MEMORANDUM DATE: May 5, 2021

RE: **222 South Lakeside Drive**

TITLE: **HRPB Project Number 21-00100083:** Consideration of a Certificate of Appropriateness (COA) for the installation of a bronze metal panel roof for the property located at **222 South Lakeside Drive**; PCN #38-43-44-21-15-101-0030. The subject property is a contributing resource within the South Palm Park Local Historic District and is located within the Low-Density Multifamily Residential (MF-20) Zoning District.

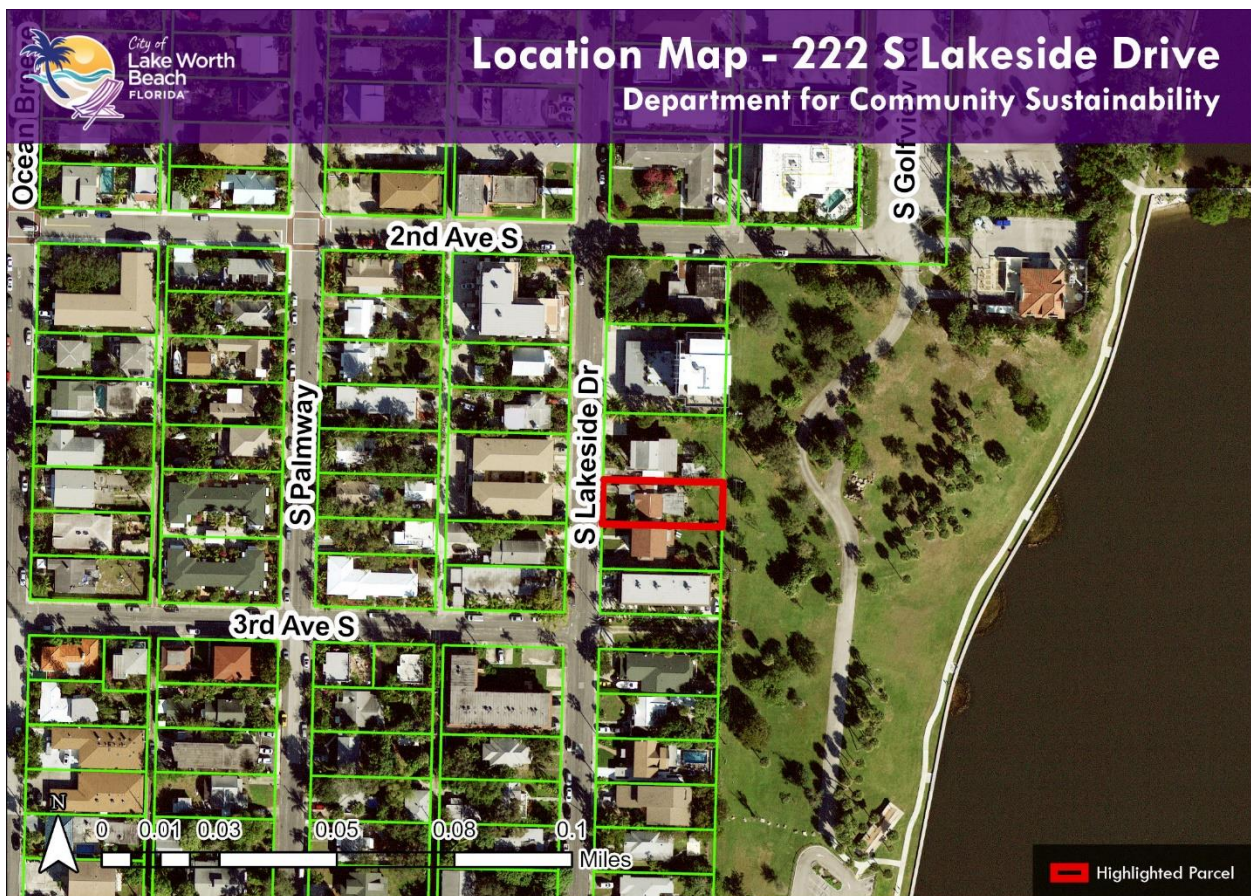
Work commenced on the project and a final inspection was performed by a Building Division representative on March 1, 2021. The project did not pass final inspection as the roof was installed with a bronze finish as opposed to the mill finish as conditioned in the COA. As staff could not approve a revision to the COA for the bronze finish (See Historic Preservation Analysis, pages 3 to 7), the project contractor brought the item to the HRPB as a conceptual review at the March 10, 2021 regular meeting. The Board did not grant staff the authority to approve alternate metal roof finishes during the meeting and the applicant was advised to return to the HRPB with a formal item. The applicant’s have submitted a justification statement for their request, included in this report as **Attachment D**. Photos of the installed bronze metal panel roof are included as **Attachment E**.

Staff Analysis: The applicants have an administrative approval to replace the roof at 222 South Lakeside Drive with a new metal panel system in a mill finish. The roof that was installed utilizes the correct profile, but is finished in bronze.

As the request is not in compliance with the Lake Worth Beach Historic Preservation Design Guidelines criteria roof replacement and HRPB precedent regarding metal roof finishes, staff is not recommending approval of the application as submitted.
